ADDENDUM 1
KUSD Bid No. 4904 F
KENOSHA UNIFIED SCHOOL DISTRICT (KUSD)
Lakeview K-8 Academy
68th St Vacation, Pick-up / Drop-off Loop Construction
6811 18th Avenue, Kenosha WI
November 12, 2025

CONSTRUCTION PLANS
for
LAKEVIEW K-8 ACADEMY
68th St. VACATION & PICK-UP/DROP-OFF LOOP
SITE GRADING, DRAINAGE, UTILITY,
& PAVEMENT IMPROVEMENTS
for
KENOSHA UNIFIED SCHOOL DISTRICT
6811 18th Avenue, Kenosha, Wisconsin

ADDENDUM NO. 1

2 OUTLET CONTROL STRUCTURE 4.0 DETAIL N.T.S.

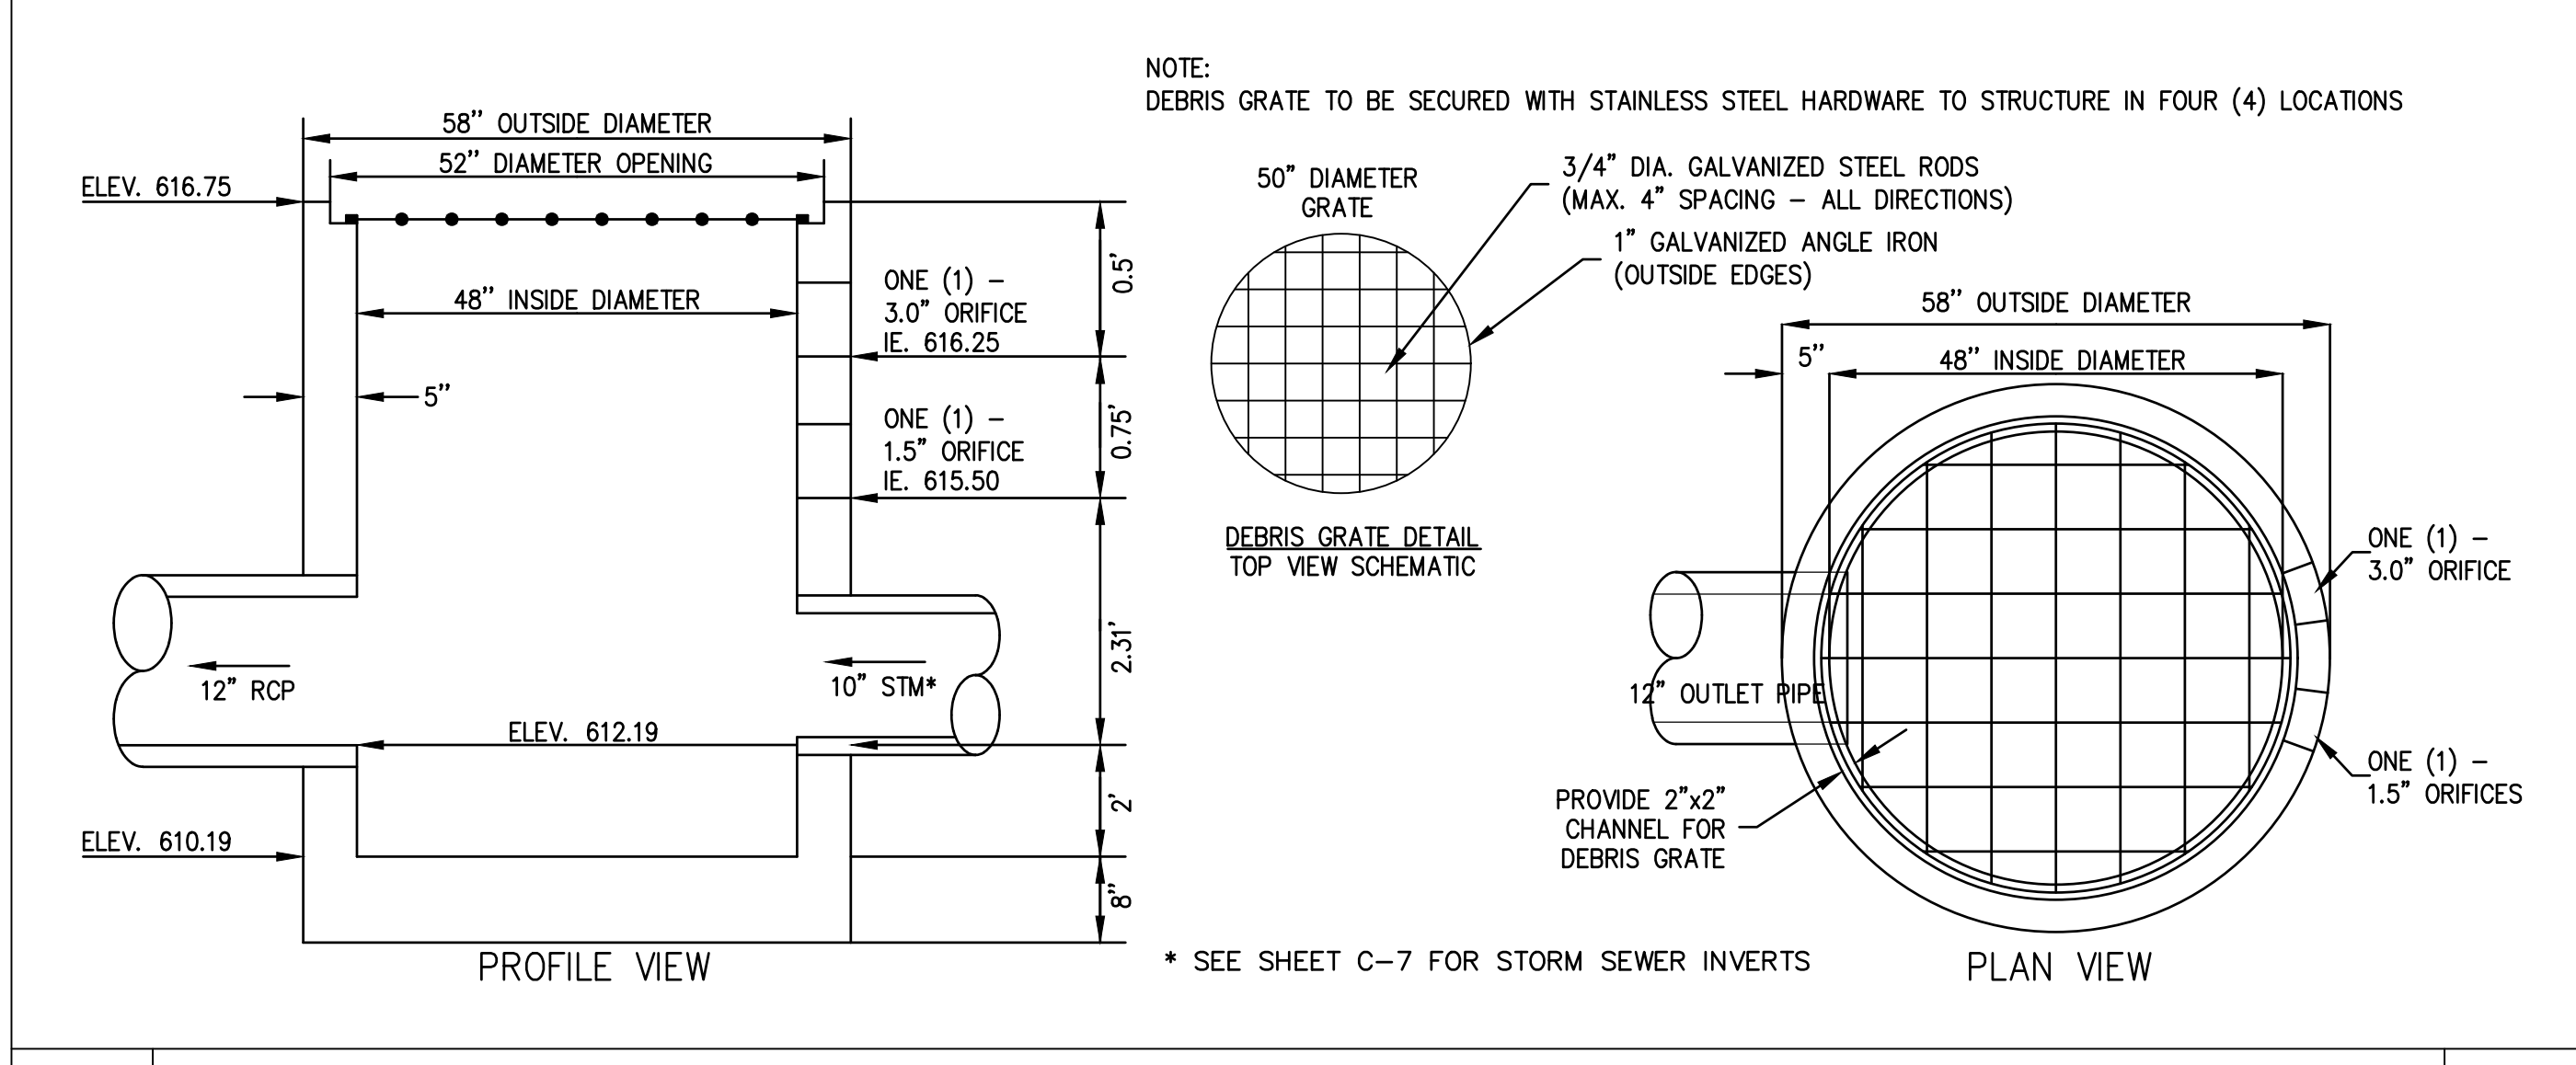
SHEET C-11

- Sheet C-11 has been added which contains the construction details for OCS's 2.0, 4.0, and 5.0.
- A construction detail has been added for the RCP / PVC pipe transition Between STM MH 1.0 and OCS2.0.

E1

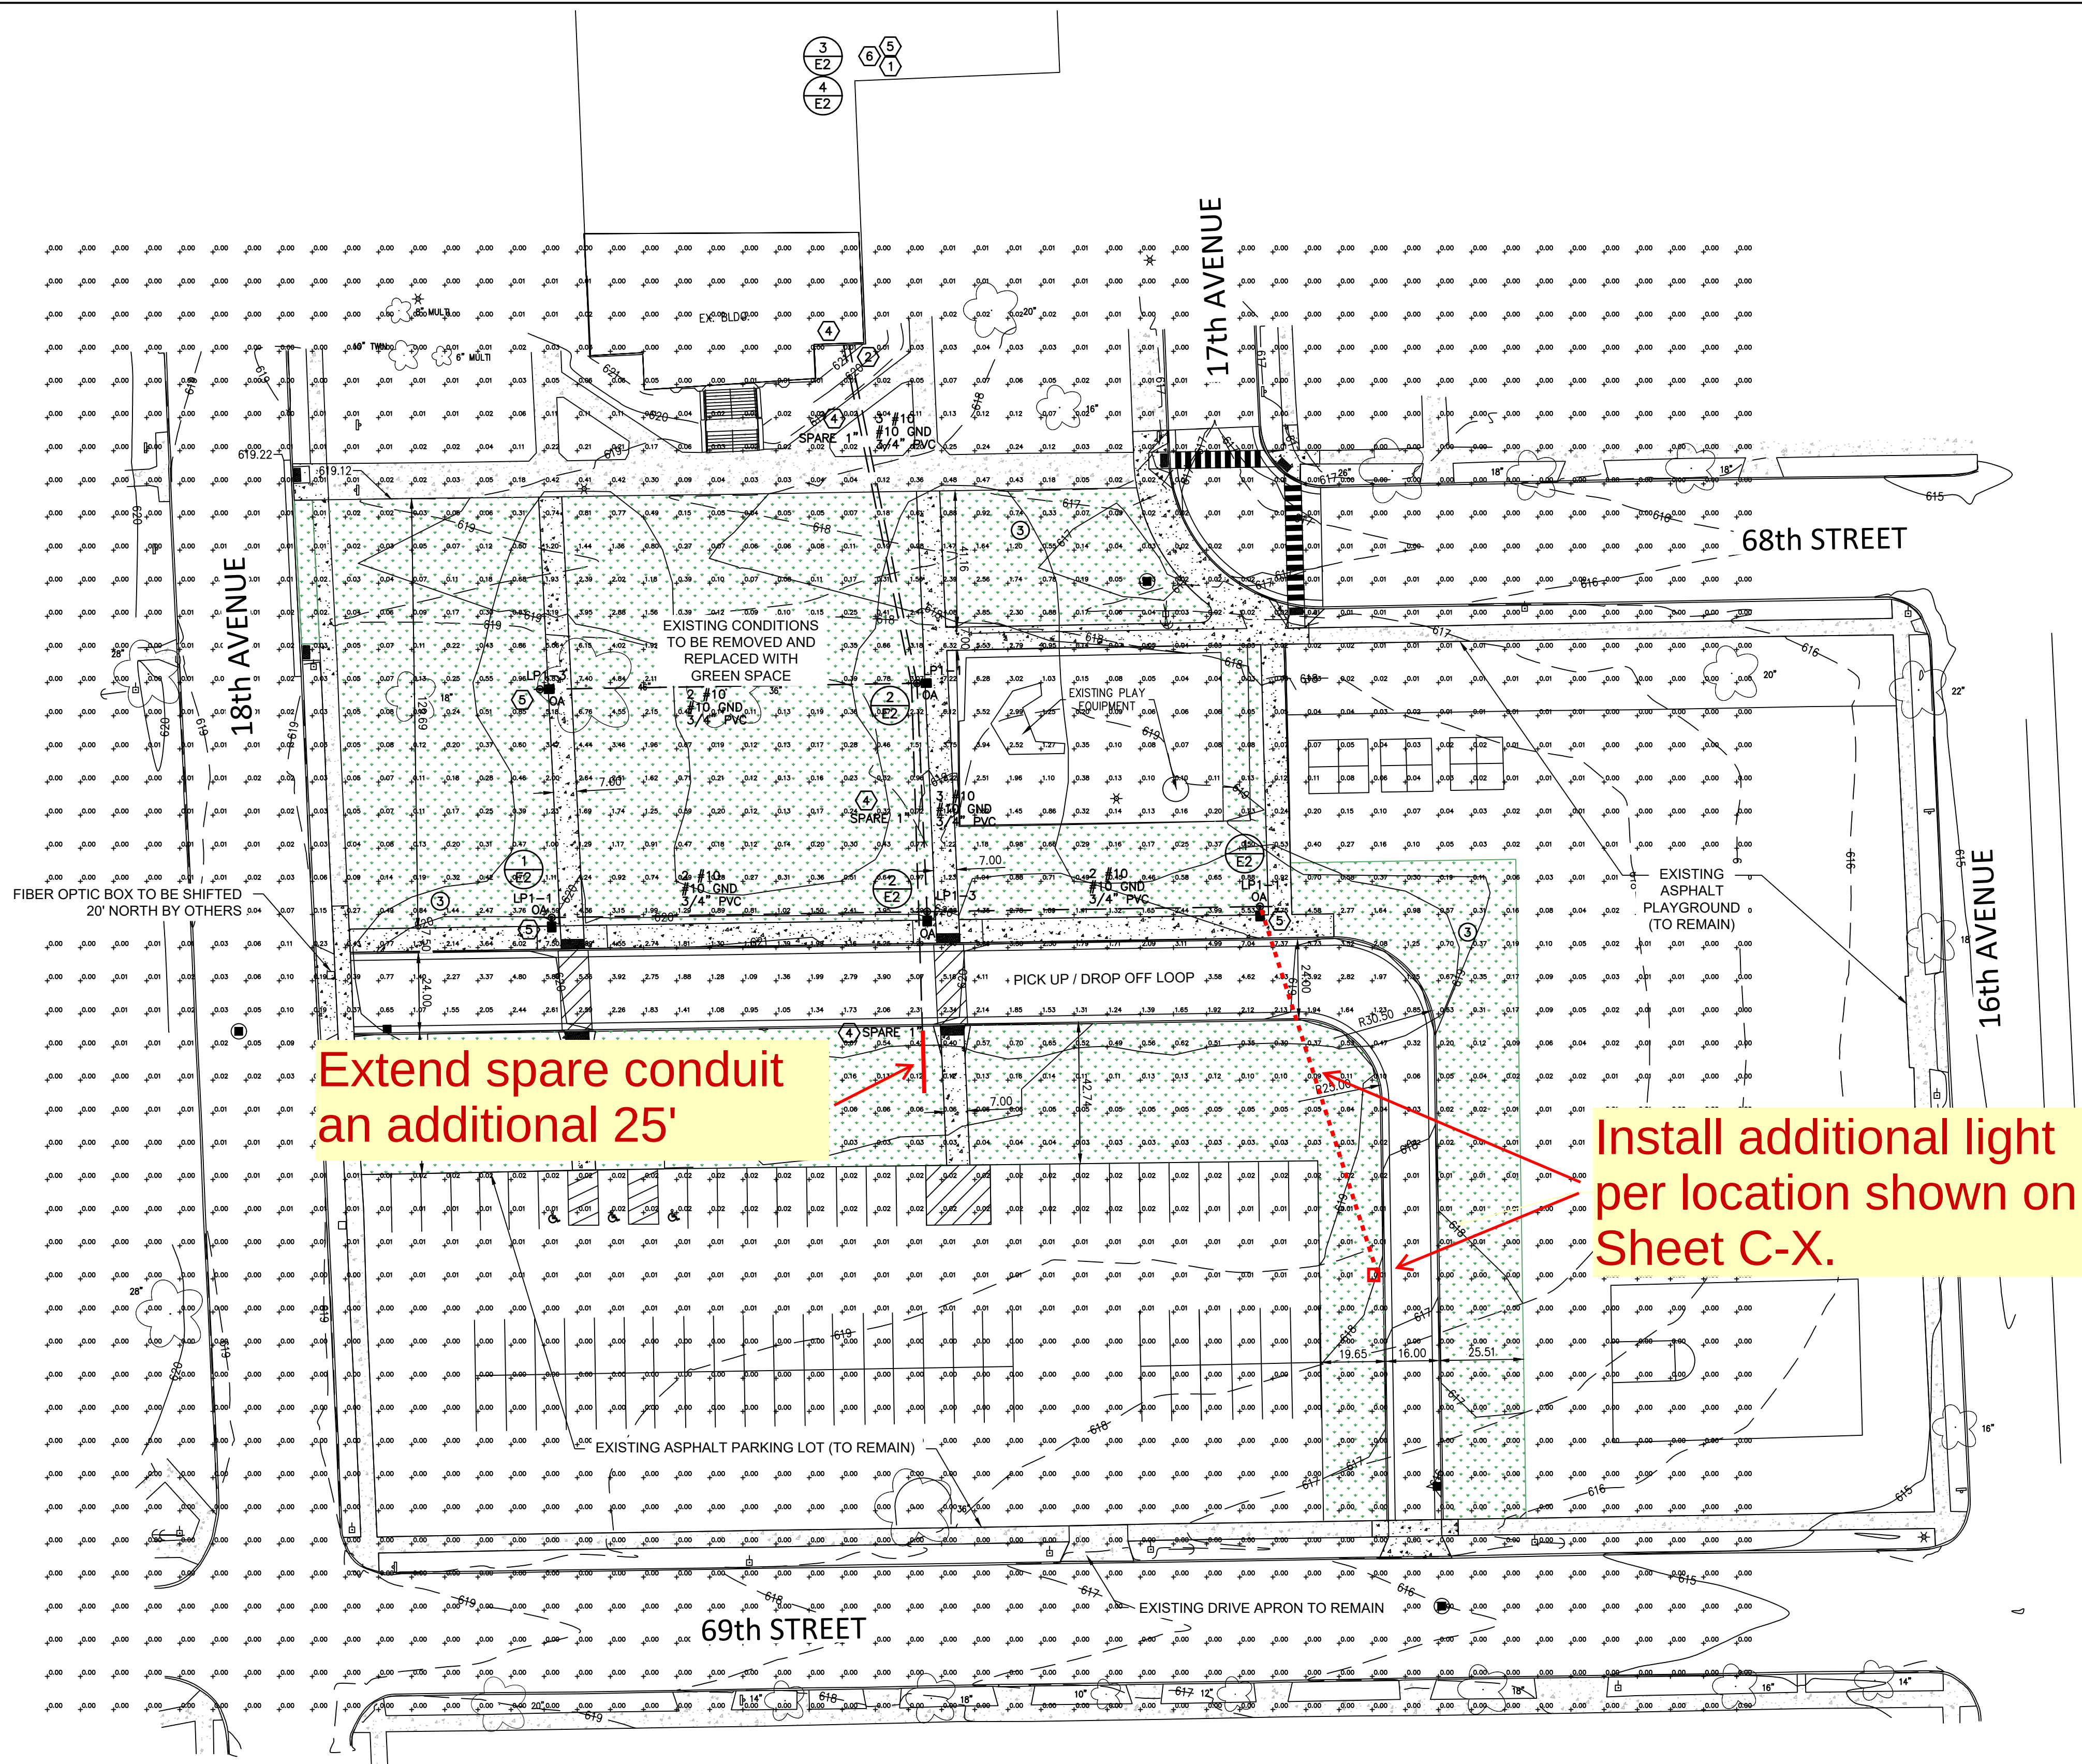
SHEET E-1

- The missing light pole and associated conduits / wiring has been added by NMB graphically.
- The conduit stub for future lighting system extension has been extended 25 LF.
-
-
-

BASEMENT FLOOR PLAN

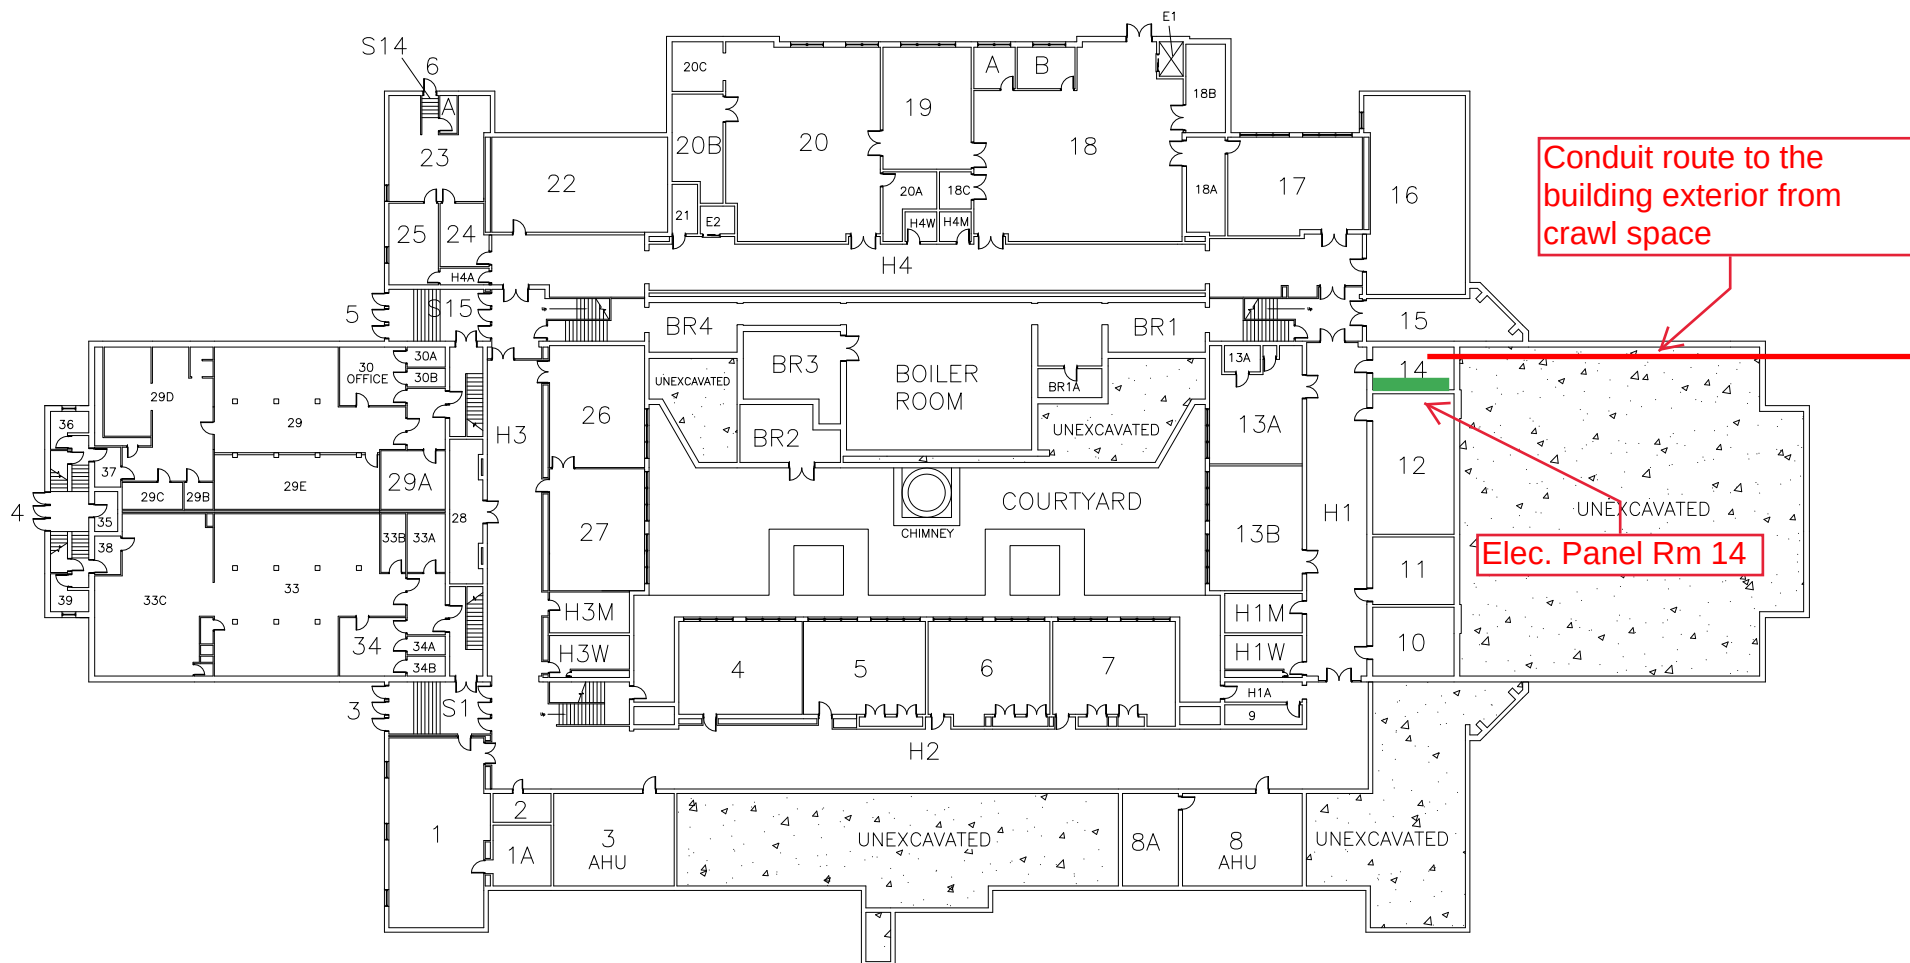
SKETCH: Basement Floor Plan

- A LakeView K8 Academy Basement Floor Plan showing the location the electrical room and conduit route for the site lighting.
